CITY OF LOWELL

**CITY COUNCIL
Conduit Location**

Review of Utility Company Request for New Conduit/Pole Location

Applicant Information		Project Address
Utility	Gas <input type="checkbox"/> Electric <input checked="" type="checkbox"/> Telephone <input type="checkbox"/>	89 Quebec St. to 118 Maple St.
(circle one)	Other <input type="checkbox"/>	Lowell, MA
Reason	Installing 2-6 inch conduit and 6-6 inch conduit on Quebec St., between Blossom St. and Maple St.

SKETCH TO ACCOMPANY PETITION FOR INSTALLATION OF
NEW MANHOLES AND DUCT BANK.
LOWELL, MA
SHEET 1 OF 4

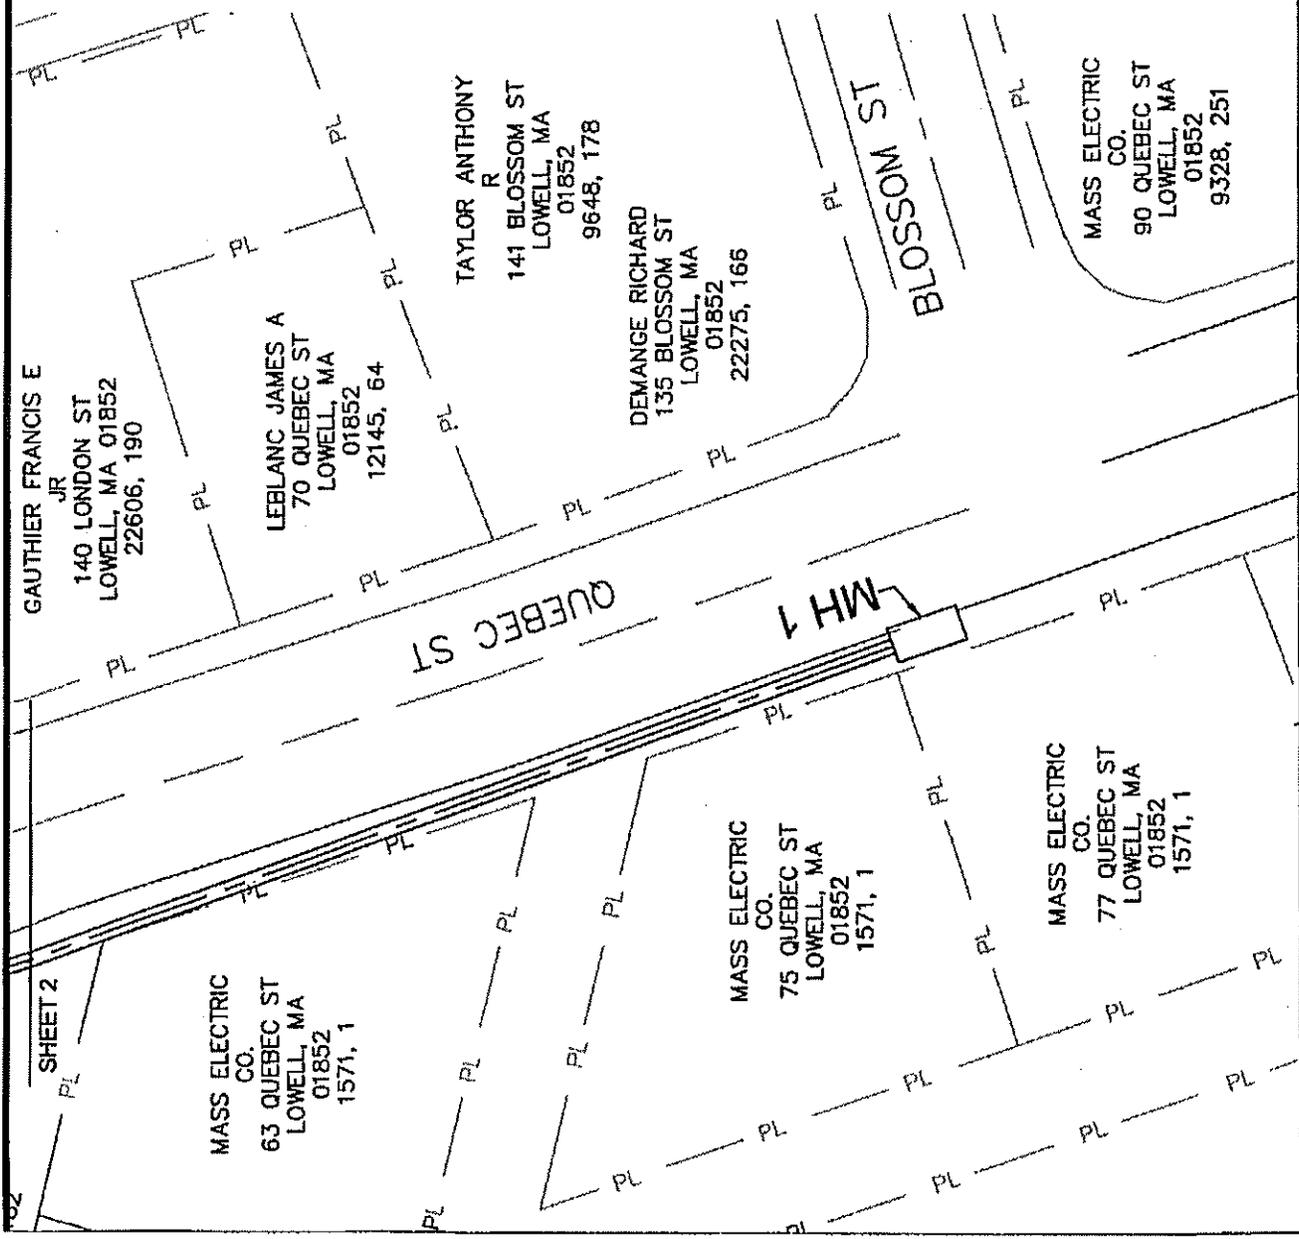
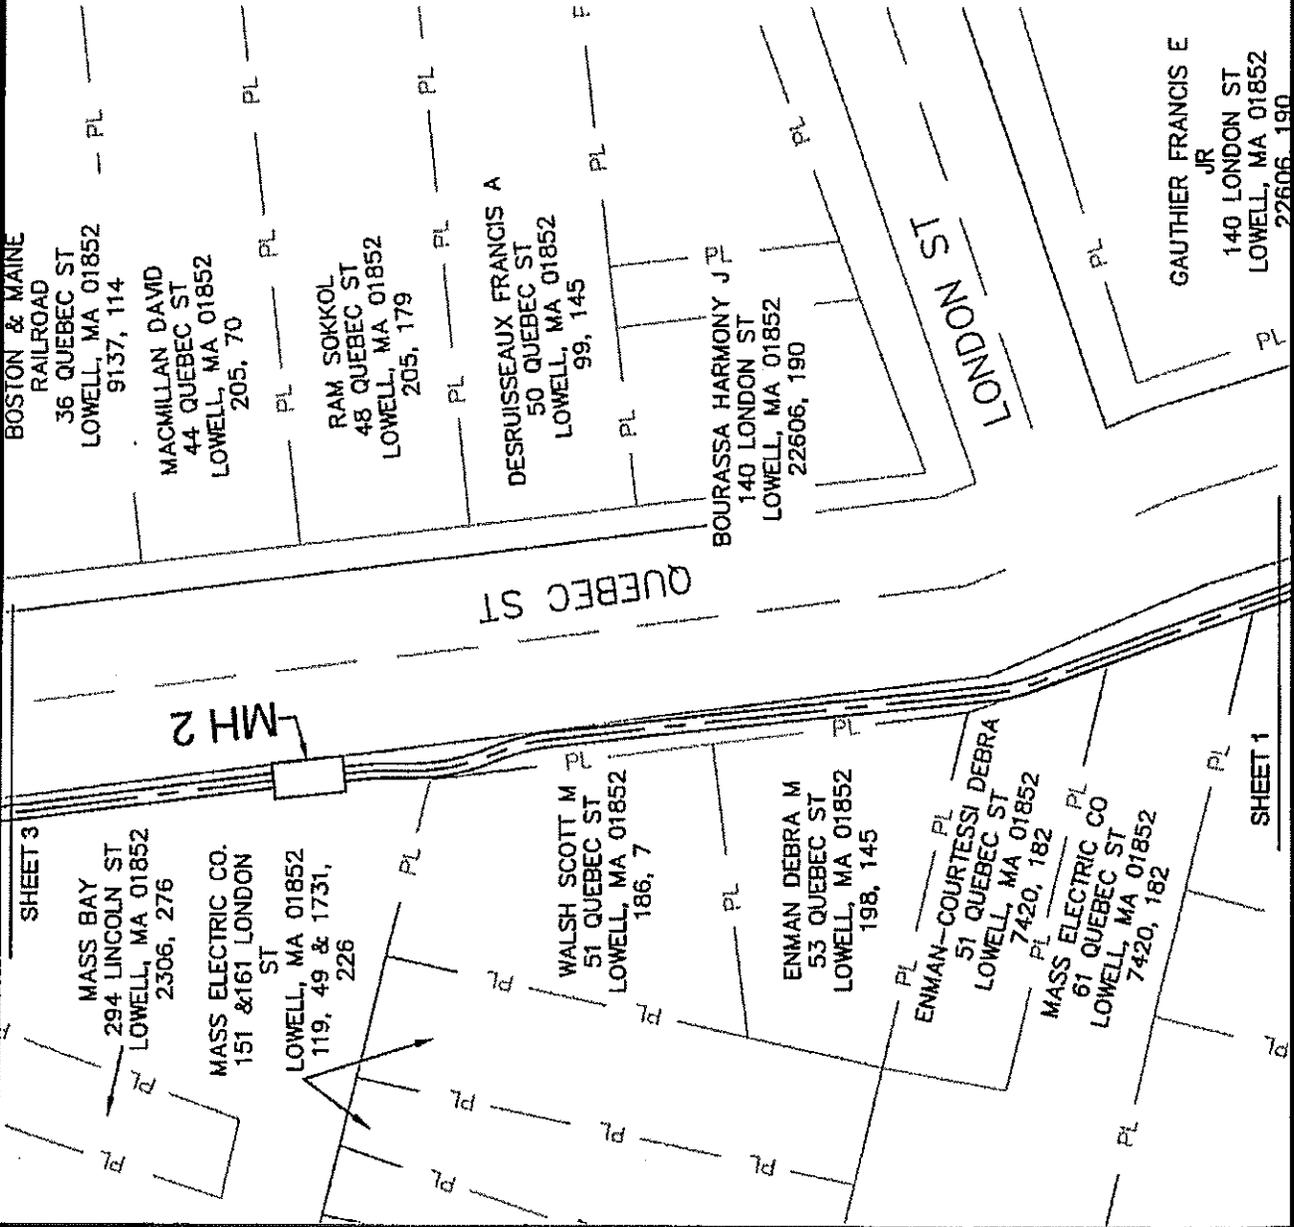
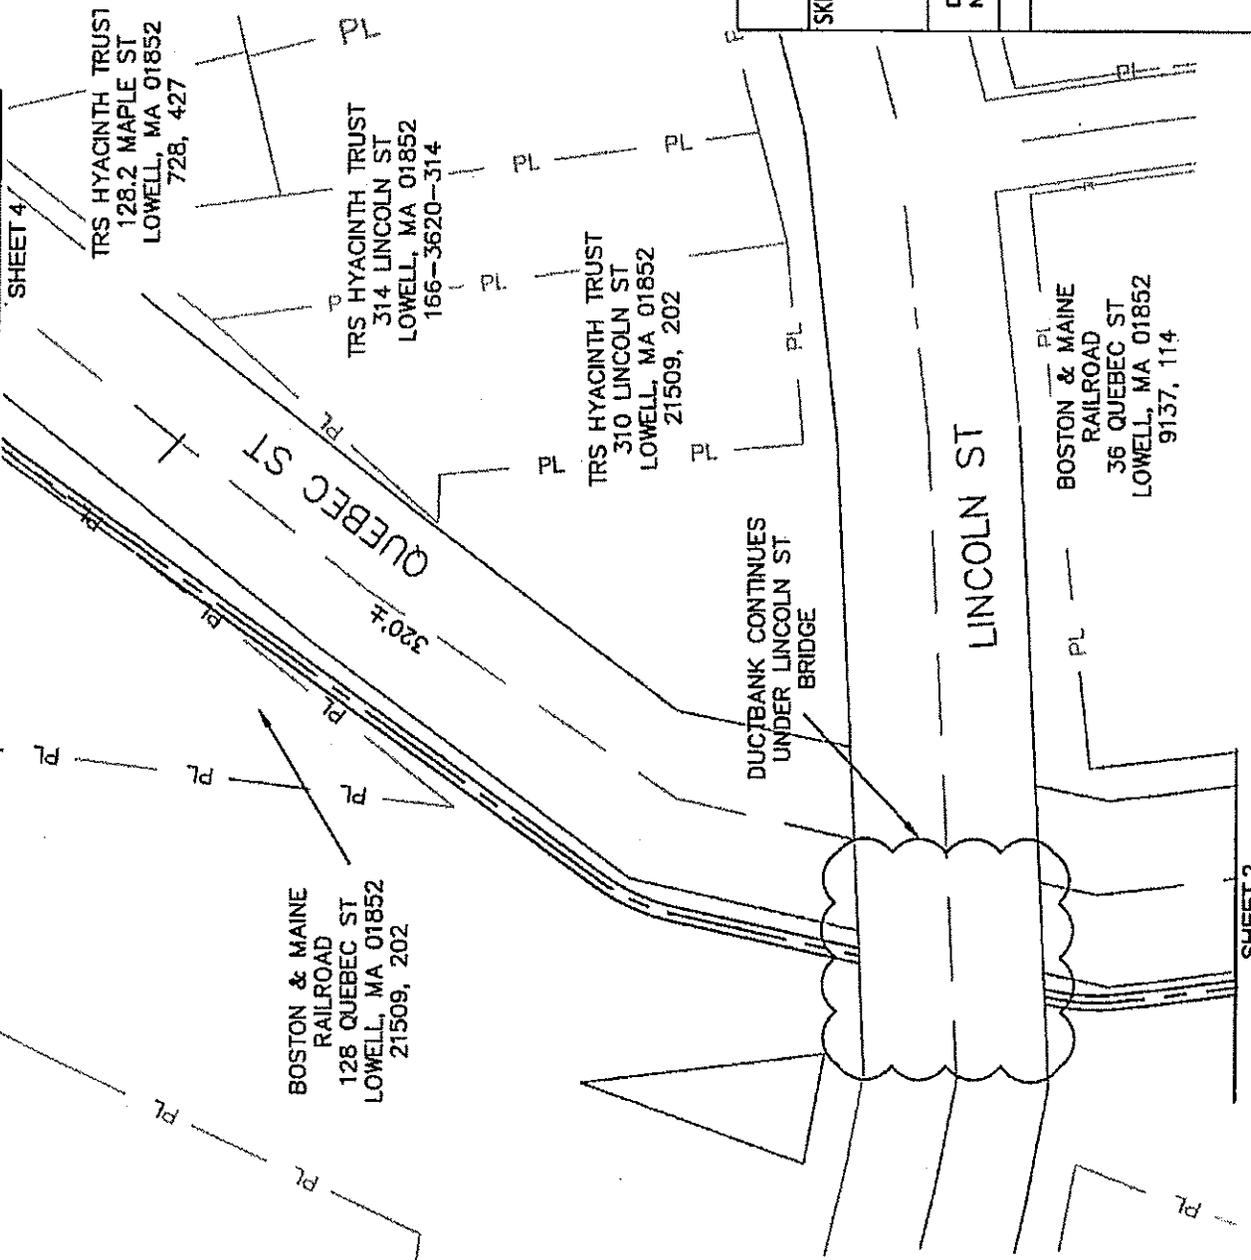
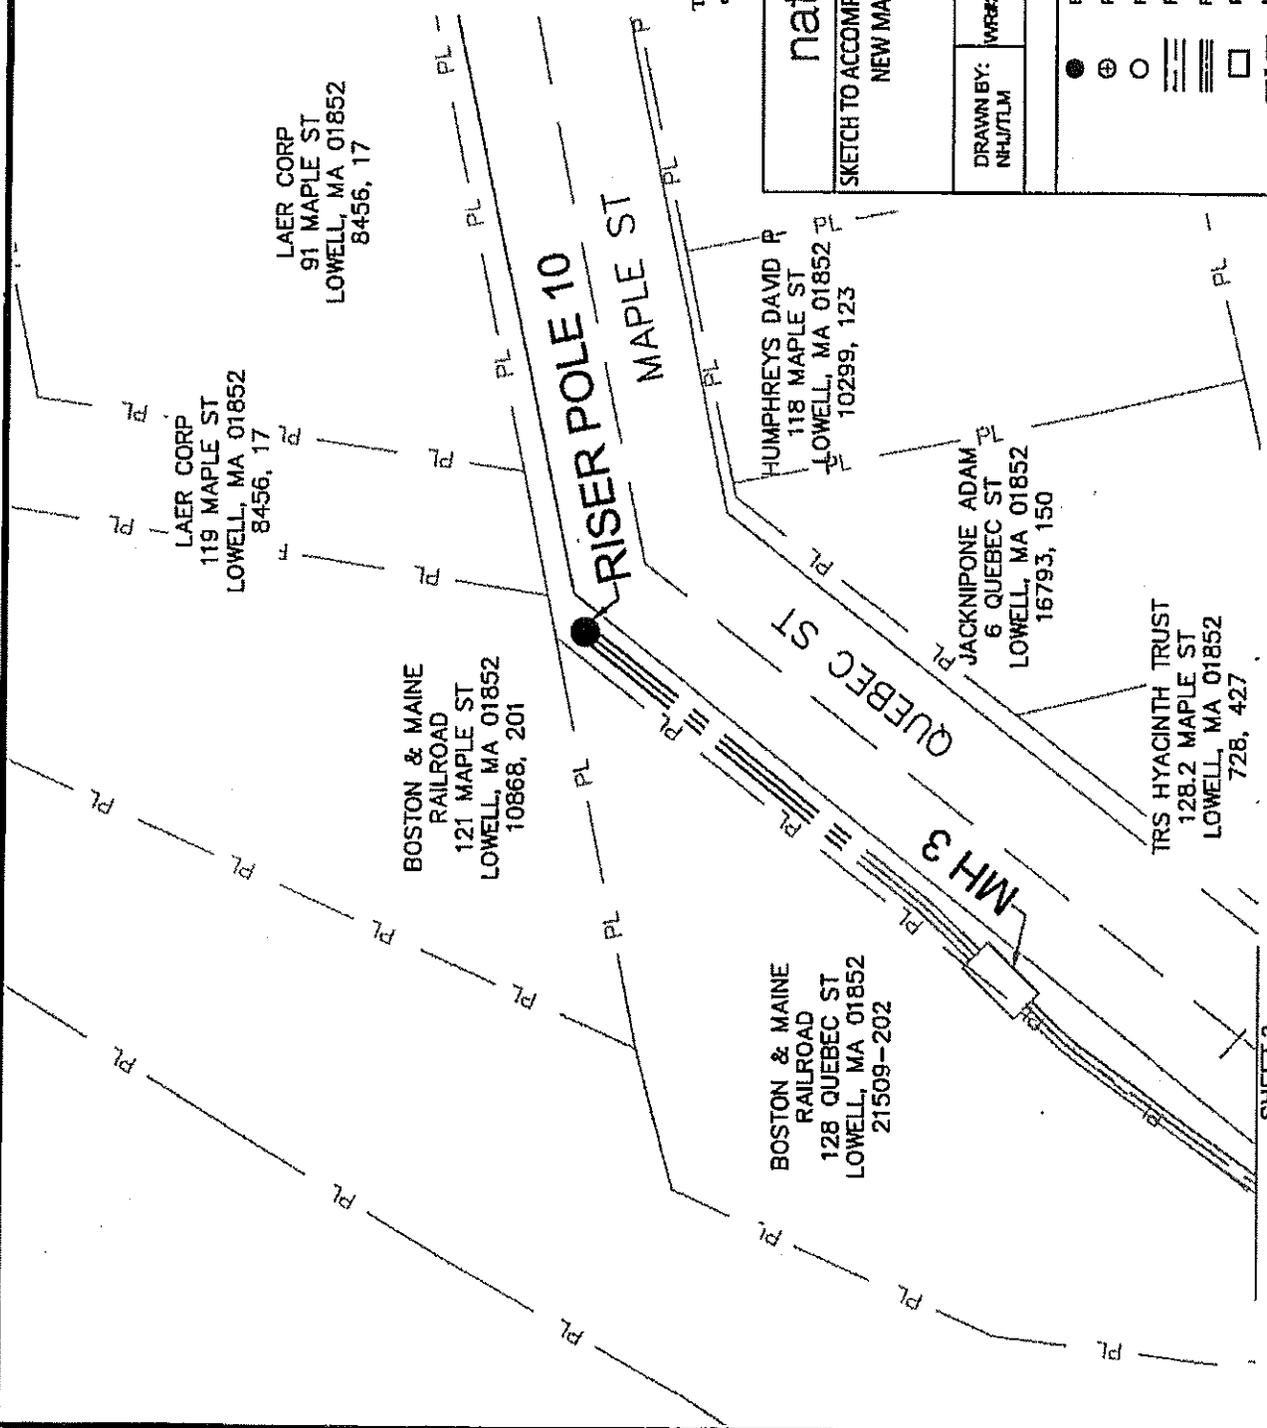
Underground conduits will be installed under dirt off the road on the Western side of Quebec Street.
 Restore disturbed pavement areas with asphalt and dirt areas with loam and seed. Obtain trench permits from City Engineering office.
 Work outside ROW requires coordination with property owners and easement coordination.
 Manholes to be flush with grade.
